TDECQ - optimizing time center of eye

Jonathan King, Finisar; Marco Mazzini, Cisco; Marlin Viss, Keysight

IEEE P802.3bs Interim Meeting, Charlotte, NC, September 2017

Illustration of the problem

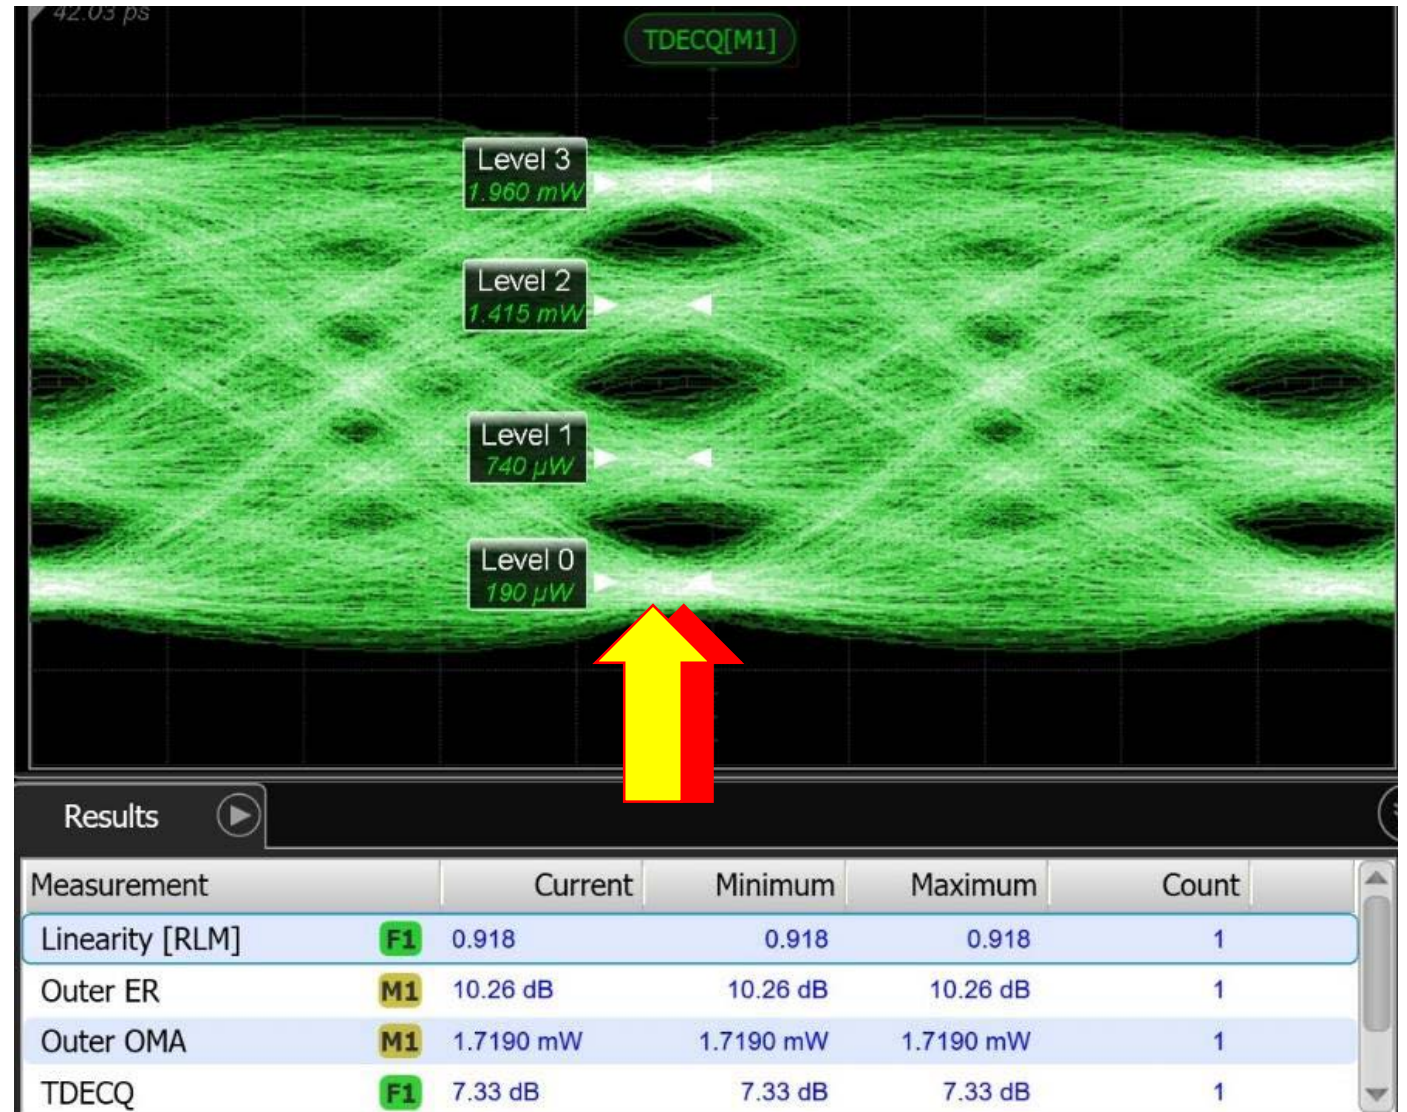
- The current definition for time centre of eye (“0.5 UI”) is based on the time average of the centre crossing points.
- This was OK for T/2 spaced reference equalizers, which would effectively optimize the equalized eye time-centre for best TDECQ.
- But it is not sufficient for a T spaced reference equalizer, which cannot optimize the time-centre of the equalized eye.
- PHYs with T-spaced equalizers are expected to optimize their sampling point, equivalent to optimizing the timing position of the histograms used to measure TDECQ.
- Therefore, the TDECQ method should be allowed to optimize the timing position when measuring transmitter eyes, to avoid penalizing or excluding transmitters which have open eyes which are offset from the time average of the centre crossing points.

- The **yellow** arrow shows where the time-centre of the eye is calculated to be, based on the current definition in D3.3
- Allowing the left and right histograms to shift to the right (to the **red** arrow) would reduce TDECQ, and would reflect the capabilities of T spaced and T/2 spaced equalizer implementations..

- In 121.8.5.3, replace the paragraph “Two vertical histograms are measured through the eye diagram, centered at 0.45 UI and 0.55 UI. Each of the histogram windows spans all of the modulation levels of the eye diagram, as illustrated in Figure 121–5. ” with “Two vertical histograms are measured through the eye diagram, **nominally** centered at 0.45 UI and 0.55 UI. Each of the histogram windows spans all of the modulation levels of the eye diagram, as illustrated in Figure 121–5. **The precise time position of the 0.45 UI and 0.55 UI histograms may be adjusted (e.g. to minimize TDECQ), but the histograms must be spaced 0.1 UI apart.**”

Figure 121-5—Illustration of the TDECQ measurement

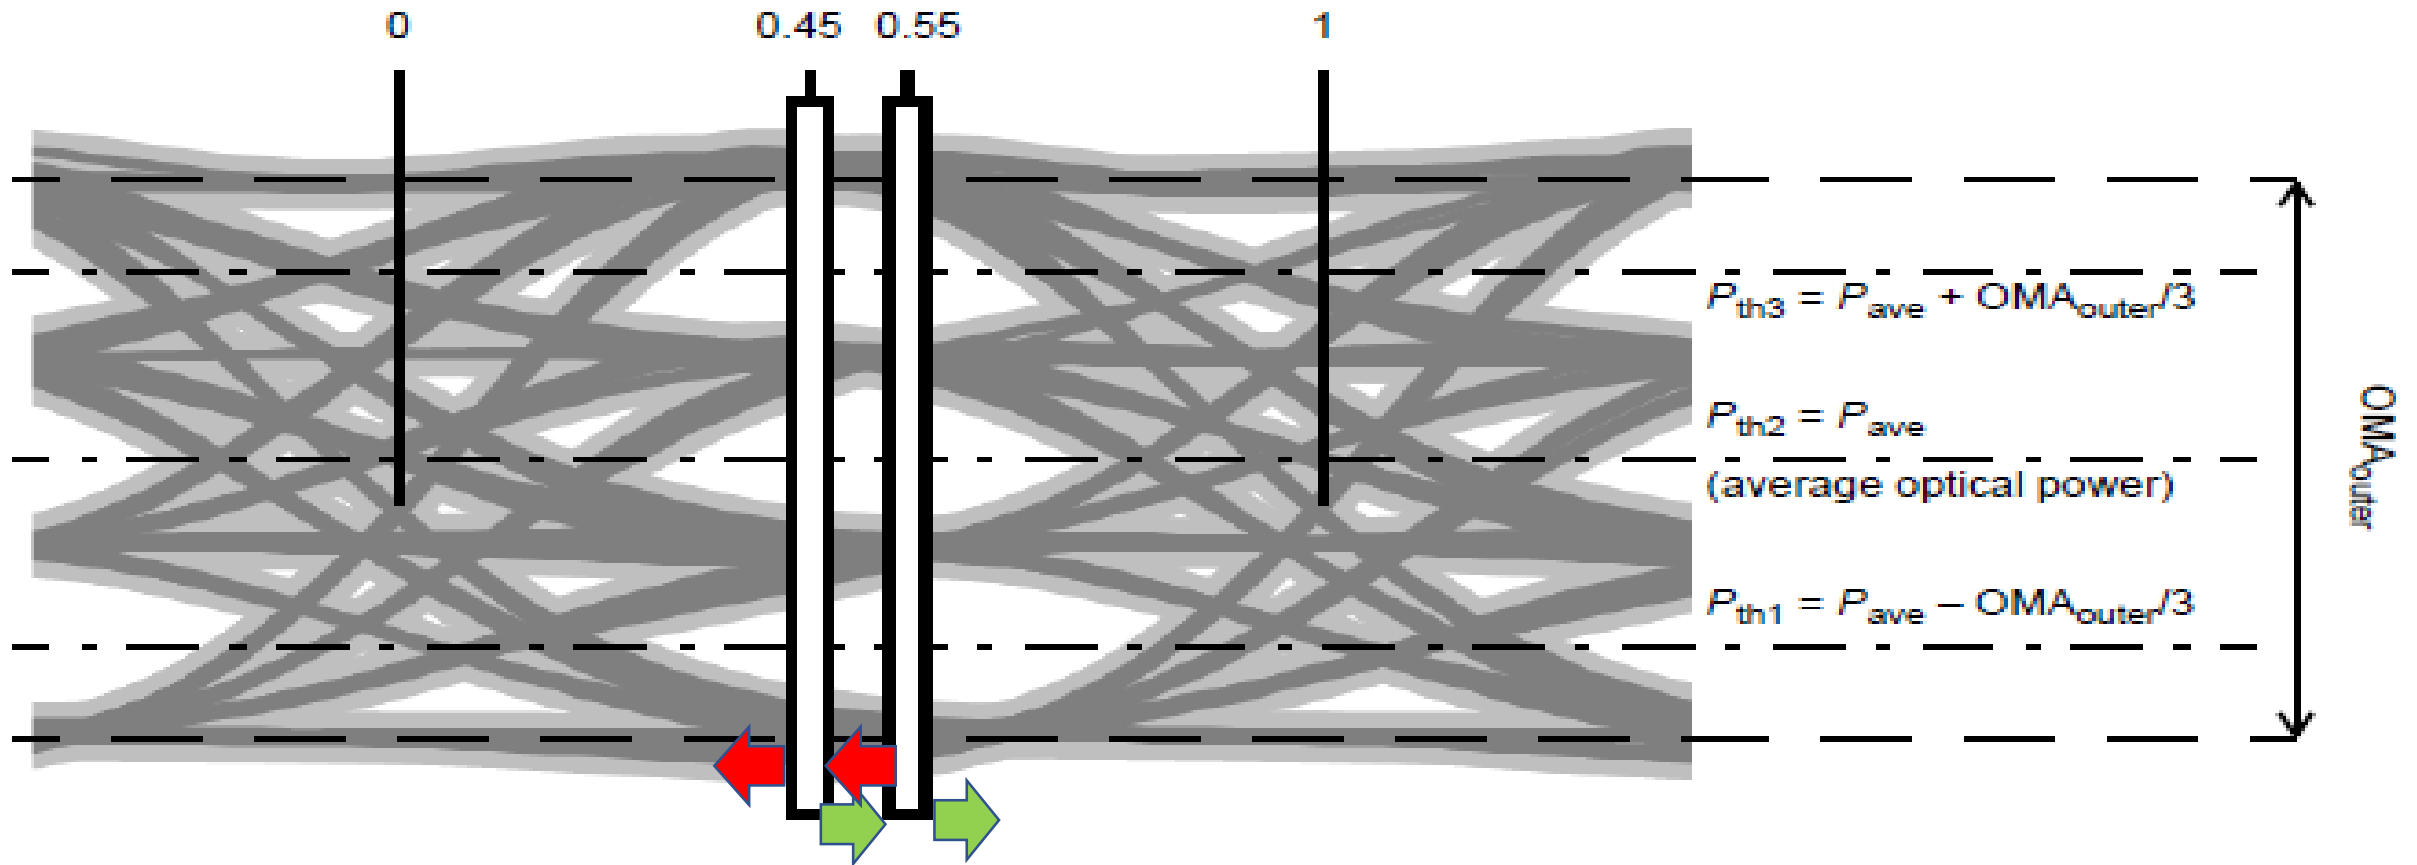
The suggested remedy allows the pair of histograms to be adjusted left or right of their respective 0.45 and 0.55 UI positions, but still requires them to be spaced by 0.1 UI

Two vertical histograms are measured through the eye diagram, centered at 0.45 UI and 0.55 UI. Each of the histogram windows spans all of the modulation levels of the eye diagram, as illustrated in Figure 121-5.
